TO: CITY COUNCIL **DATE:** SEPTEMBER 13, 2004
FROM: CITY MANAGER
SUBJECT: PREDEVELOPMENT PLAN REVIEW FOR NEW CONSTRUCTION OF A
RESEARCH/OFFICE BUILDING AT 686-700 SOUTH RAYMOND
AVENUE

PPR2004-00019

Attachment C
PPR Comments from City Staff

PROPOSED SITE PLAN MAY 12, 2004

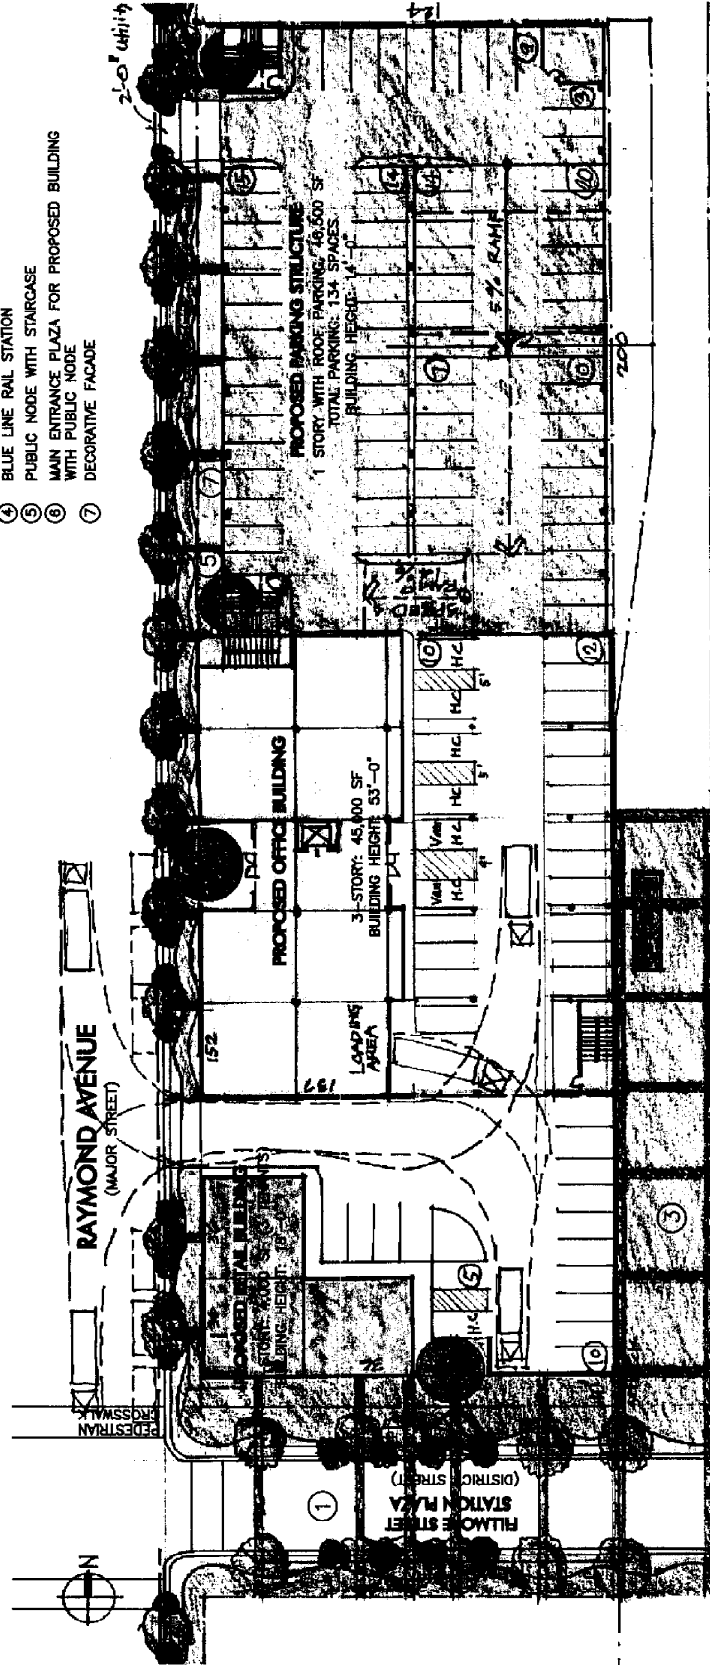
It is not clear on the preliminary plans if this requirement is being met. Before the project is submitted for Design Review, make sure that Current Planning has verified the location and square footage proposed for the open space requirement.

Based to the information provided on the plans, the number of loading spaces is not in compliance with the number required per code. Revise the plans to comply with the loading space requirements.

Site Design: At the south-east corner of the site, along Fillmore Street, the absence of retail space, landscaping, and other amenities “inviting to pedestrians” should be restudied. The proposal for surface parking abutting a stretch of Fillmore Street is inconsistent with the emphasis throughout the specific plan on activating the streetscape in this location. One alternative might be to introduce a linkage of some kind similar to the glazed bridge between the office building and the parking structure. Another approach might be to add enhanced landscaping and other pedestrian-friendly features to the short frontage on Fillmore Street. Along Raymond Avenue, the street-facing edge of the parking structure also requires special attention; features that add pedestrian interest—such as color, landscape, and texture—should be proposed for this important elevation. The recommended treatments for walls in the specific plan (pp. 48-49) might be helpful to develop an appropriate design for the base of the parking structure.

Landscaping: The tree inventory should be refined to indicate which trees are protected specimen trees, under the City’s tree protection ordinance. At least

four of the trees (oaks; bottle brush) are subject to the tree protection ordinance. The oak tree appears to be in the location of the public node off Raymond Avenue; in that event, this tree—if healthy and aesthetically suitable—should be retained for use in this location. Possibly the palm trees affected by new construction could be relocated and integrated into a new landscape design. The edge of the site along the light rail tracks may also be an opportunity for creative landscaping.

PROPOSED ELEVATION FROM S. RAYMOND AVENUE MAY 27, 2004
 MIXED USE DEVELOPMENT | ALEXANDRIA REAL ESTATE EQUITIES | 686-700 S. RAYMOND AVENUE, PASADENA, CA 91105-3253

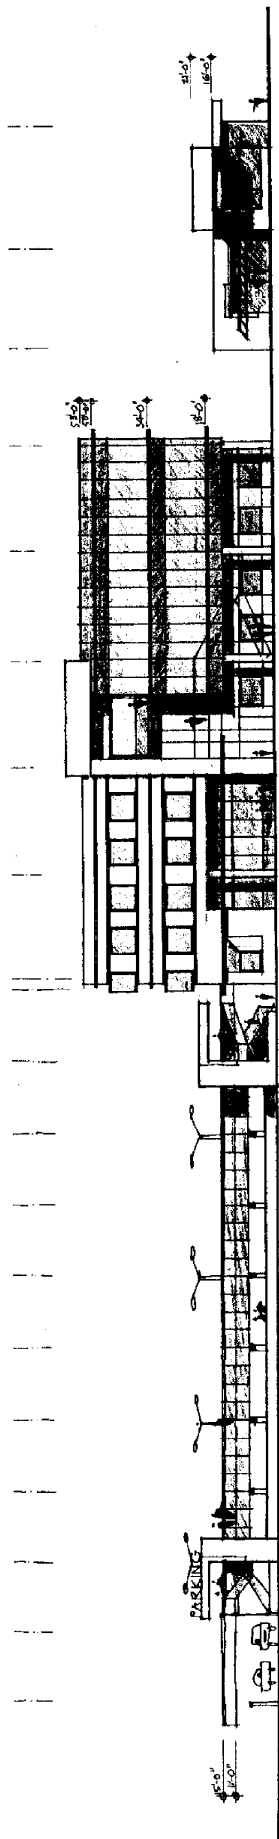
Based on the preliminary building elevations, the proposed retail building is 21 feet in height, and the office building is approximately 53 feet in height with an additional appurtenance over 53 feet. It appears that the appurtenance is in compliance with the height requirements, but the city needs a scaled set of building elevations to verify the height requirements.

Massing: The corner retail module may be too under scaled to fulfill the intent of the specific plan to create a “district-wide focal point of activity” at the Fillmore Station Plaza. Compare, for example, the proposed 18-foot module to the conceptual illustrations in the specific plan on pp. 28 and 30.

Building Elevations: The multifaceted composition of the primary building follows the direction in the specific plan to use volume, massing, materials, and proportion and scale to express activities and functions. The juxtaposition of glass-curtain walls with a large cantilevered centerpiece and five bays of projecting windows is challenging for a building with a relatively small footprint. The synthesis of these features will be a major consideration during design review. The commitment to employ protruding window assemblies with strong geometries is commendable. This infusion of innovative design to this area presents an opportunity to support a burgeoning “community of interest and identifiable district image” with “visual vitality” to South Raymond Avenue [p. 11, specific plan]. The roofline of the building should be designed to conceal roof-top mechanical equipment (or to otherwise organize roof-top appurtenances as part of the architectural organization of the building) [p. 57, specific plan]. The design guidelines for the specific plan encourage cornice lines on new buildings [p. 19].
